# AUDENSHAW SCHOOL

## ACCESSIBILITY AUDIT ACTION PLAN FEBRUARY 2024

*VERSION 20 – UPDATED JANUARY 2026*

## Section 4 – Action Plan

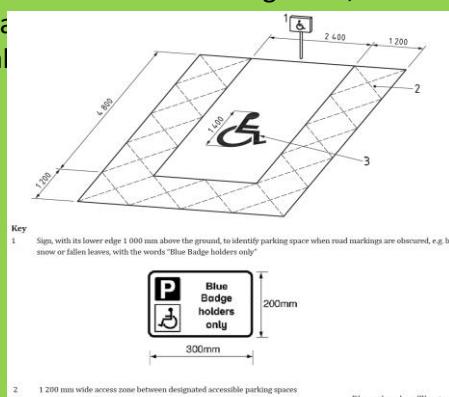
12.5	<p>Urinals throughout do not have grab rails to aid people with ambulant disabilities.</p> <p>The PE block ground floor urinal require better contrasting.</p>	<p>A well contrasted grab rail should be provided to one urinal in every WC where applicable.</p> <p>An unobstructed space of at least 900 mm wide x 1 400 mm deep should be provided in front of a urinal to allow access by a wheelchair user</p> <p>BS8300 States: Urinals should contrast visually with the wall to which they are attached.</p>	OG	<p><b>New Grab Rails installed on all urinal areas – May 25.</b></p>
